VKM 23244

Technical Bulletin - February 2006

PSA 1.9 D (DW8 engines) & PSA 2.0 HDi 8V (DW10 engines)

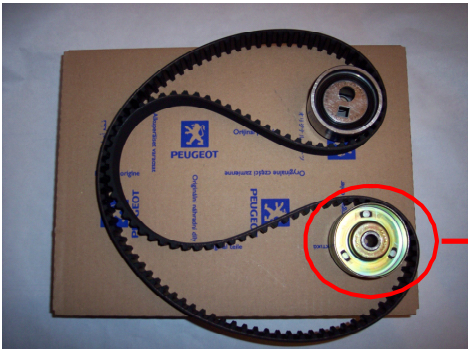
VKM 23244 has been replaced by VKM 23246.

As the new design is common with the timing idler in VKM 23246, VKM 23244 has been replaced by VKM 23246.

Old OES kit content for
VKMA 03244/03247

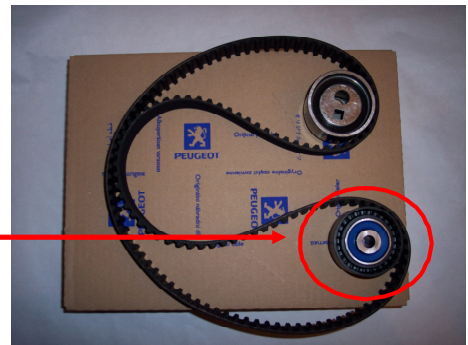
PSA has recently modified the content of OES kits for the DW8 and DW10 engines, in fact the timing idler went through a design evolution.

The new design of the timing idler has a plastic pulley whereas the old design has a metal pulley.

New OES kit content for
VKMA 03244/03247

New SKF VKMA 03244 / 03247 content
